Model: V-C1 Punch Unit Type 3260	Date:4-Sep-09	No.: RB700005
----------------------------------	---------------	---------------

Subject: Parts Registration (Punch Unit Type 3260)		Prepared by: T.Toriumi	
From: 2nd Tech. Support Sec. Service Support Dept.			
Classification:	<input type="checkbox"/> Troubleshooting <input type="checkbox"/> Mechanical <input type="checkbox"/> Paper path <input type="checkbox"/> Other ()	<input checked="" type="checkbox"/> Part information <input type="checkbox"/> Electrical <input type="checkbox"/> Transmit/receive	<input type="checkbox"/> Action required <input type="checkbox"/> Service manual revision <input type="checkbox"/> Retrofit information

Model: Punch Unit Type 3260

Subject: Parts Catalog Correction

1. Punch Unit 1 (B702)

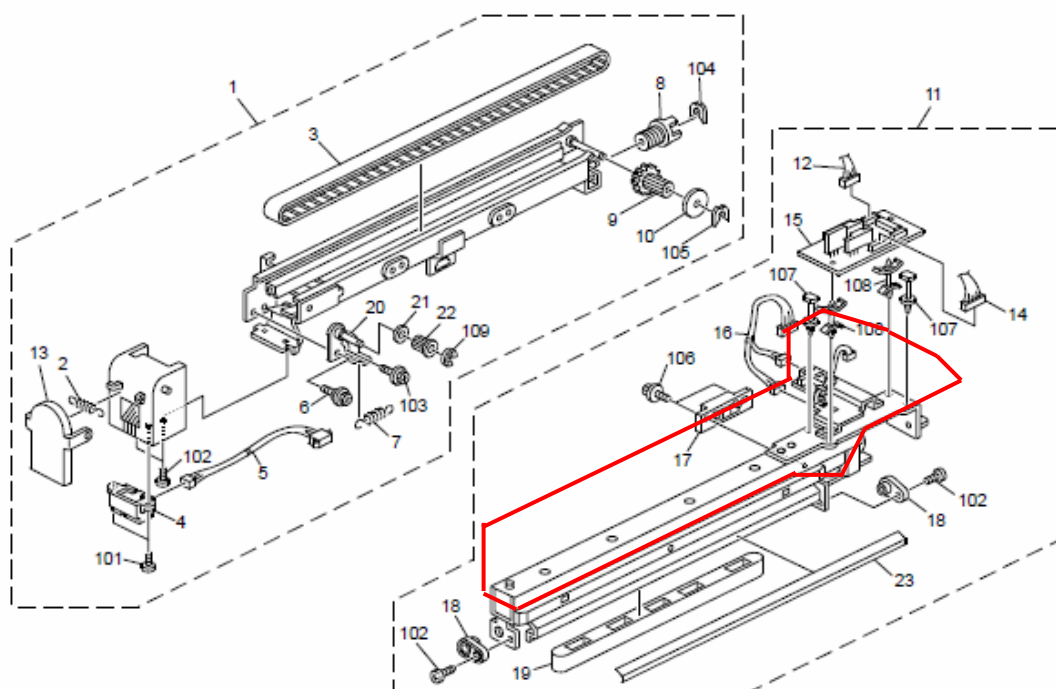
Change: The punch unit assembly was added (circled in red in the illustration).

Reason: To enable the assembly to be replaced in the field.

Important: The component parts of the assembly, such as the motor, cannot be replaced individually in the field. This is because they can only be removed and installed using specialized equipment at the factory.

Old part number	New part number	Description	Q'ty	Int	Page	Index	Note
-	B7027357	PUNCH UNIT:NA: CHANGE:ASS'Y	0-1	-	3	24	New Index
-	B7027367	PUNCH UNIT:EU: CHANGE:ASS'Y	0-1	-	3	25	New Index
